# Command set proposal ~BCA Read Command

Blu-ray Disc Association  
TEG5

07-423R0

**Table 3** b) Structure Format Code Definitions for Media Type 0001b (= BD)

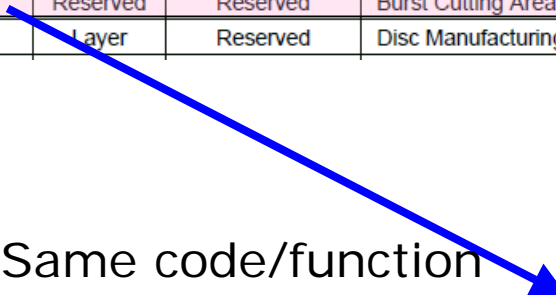
Add Same code/function
